RE: Submission to Sydney Metro Victoria Cross Over Station Development

We thank you for the opportunity to comment on the proposed Concept State Significant Development Application (SSD 8874) for the Sydney Metro Victoria Cross Over Station Development (OSD). This submission has been prepared by Ethos Urban on behalf of LIF Pty Ltd as Trustee for the Local Government Property Fund, who own a nearby property at 76 Berry Street, North Sydney (refer to **Figure 1**).

Figure 2 Extract of Ground Floor Concept Plan

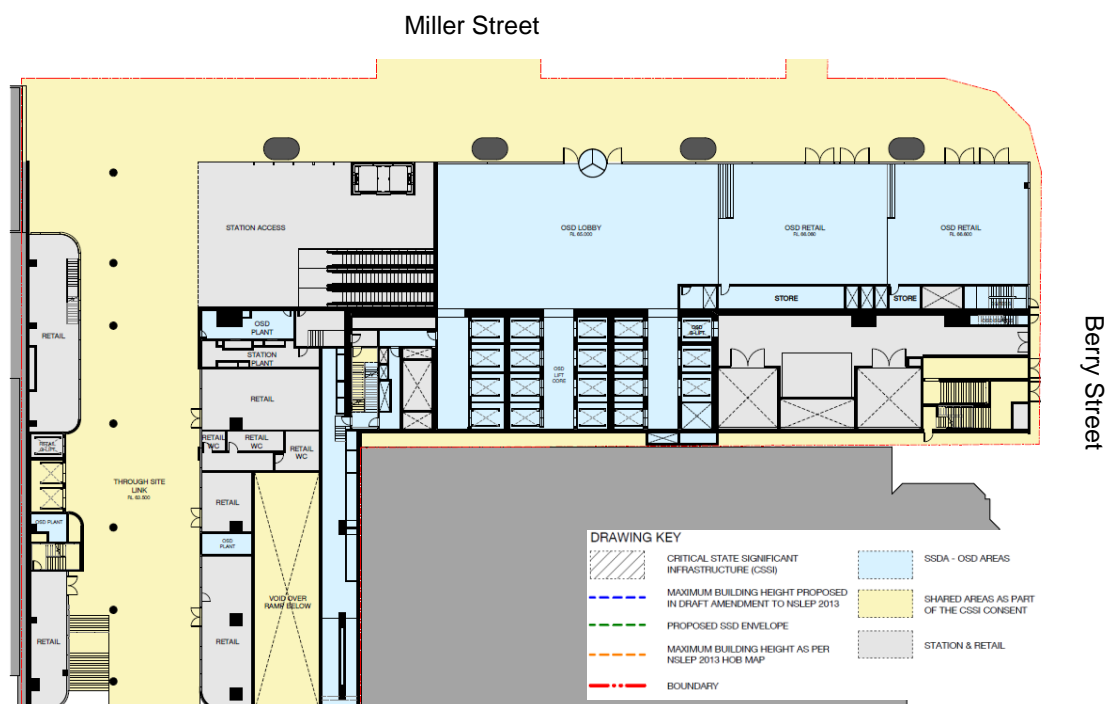
The indicative architectural scheme supporting the concept plan, orientates the ground floor of the building to Miller Street with all retail tenancies and the main OSD lobby opening toward this frontage (refer to **Figure 2**). The detailed design of the building should further consider the Berry Street frontage and seek to activate this street as well due to its role as a key east-west connection and due to its interface with the future Ward Street Precinct.

The detailed design of the building should also further consider the provision of active uses along the Berry Street frontage given its interface with the future Ward Street precinct.
